# Access Compliance Report

## Public Rights-of-Way

### (Curb Ramps)

Intersection ID: 50604	Main Street: RHODORA_RD	Cross Street: LAMINA_CT	Location: SW
ADA ID: 75F90869F703	Ramp Type: Perp	Initial Pass/Fail: Fail	Overall Compliance: No
Severity Score: 10			
Codes/Mitigation Info/Possible Solution		Field Measurements/Component Compliance

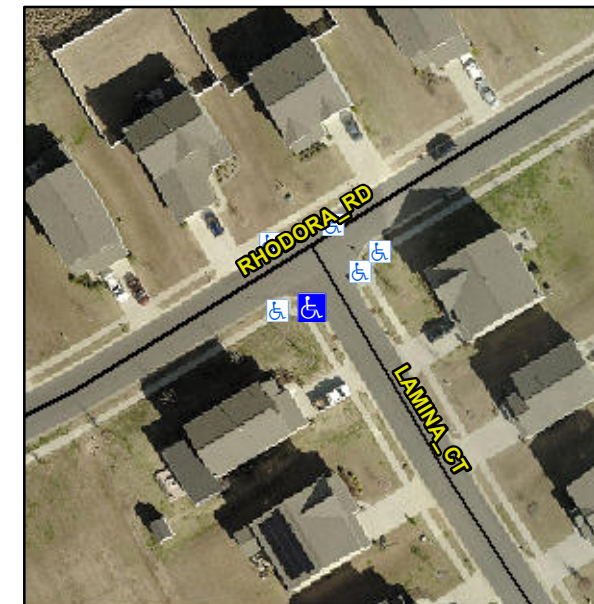
**Not Found, R304.5.1, R304.5.3**

Compliance	Description	Data	Compliance	Description	Data
N/A	Ramp Length (in)	48.5	Yes	Ramp Slope (%)	5.7
No	Ramp Width (in)	46.0	No	Ramp XSlope (%)	3.5
N/A	Flare Type LT	N/A	N/A	Flare Type RT	N/A
N/A	Flare Slope LT (%)	N/A	N/A	Flare Slope RT (%)	N/A
N/A	Flare Traversable LT?	N/A	N/A	Flare Traversable RT?	N/A
N/A	Landing Length (in)	N/A	N/A	DWS Provided?	N/A
N/A	Landing Width (in)	N/A	N/A	DWS Contrast?	N/A
N/A	Landing Slope (%)	N/A	N/A	DWS Length (in)	N/A
N/A	Landing X Slope (%)	N/A	N/A	DWS Full Width?	N/A
N/A	Landing Curb? (Y/N)	N/A	N/A	DWS Offset (in)	N/A
N/A	Shared Landing?	N/A			
N/A	Gutter Ponding?	N/A	N/A	Gutter Slope (%)	N/A
N/A	Gutter Lip Ht (in)	N/A	N/A	Gutter X Slope (%)	N/A
N/A	Painted X Walk1?	No	N/A	Painted X Walk2?	N/A
	X Walk 1 Direction	To E		X Walk 2 Direction	N/A
N/A	X Walk 1 Width (in)	N/A	N/A	X Walk 2 Width (in)	N/A
	X Walk 1 Slope (%)	2.8		X Walk 2 Slope (%)	N/A
	X Walk 1 X Slope (%)	0.7		X Walk 2 X Slope (%)	N/A

**Remove & Replace Entire Ramp.**
